CITY PLAN COMMISSION STAFF REPORT

Project Name
Mayfair Development

Request
CD-CPC-2024-00108
Development Plan

Case Number: CD-CPC-2024-00108

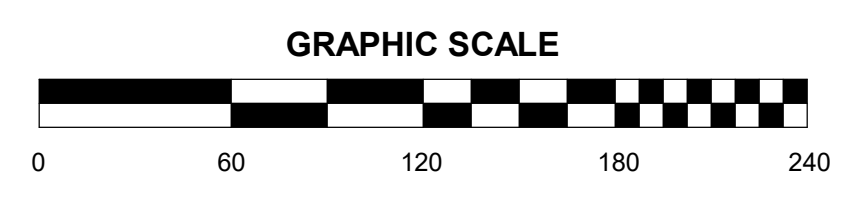
4. Table 5 on sheet A1 states to see Addendum 1 for the Parkland Dedication requirements, but the Addendum is not attached. Please revise. 8/22/24 Update - An addendum has still not been provided. Please Revise. (8/19/2024)
5. Our records indicate that Parkland Dedication was not required for the previous use. Please either provide information showing that the Parkland requirement was satisfied with the previous development, or update the plans to include a Parkland Dedication table showing how you intend to satisfy the requirements per 88-408. 8/22/24 Update - The prior uses on the site were not subject to the Parkland Dedication requirements. As the use is changing to a typical residential development, the Parkland Dedication requirements are required for the residential units being created. (8/19/2024)

1 LANDSCAPE DEVELOPMENT PLAN
1" = 50'

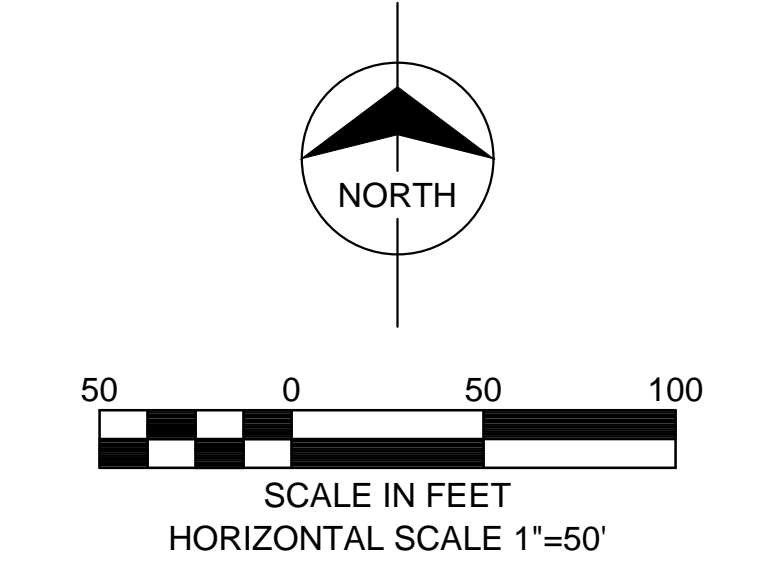
1. Provide landscape plan prepared by a landscape architect in compliance with Section 88-425-12 of the Zoning and Development Code. Existing, required, and proposed landscape quantities must be provided in the table and landscaping should be clearly identified on the plan drawing. UPDATRE 8/21/24: Metrics not included in the table. (8/19/2024)
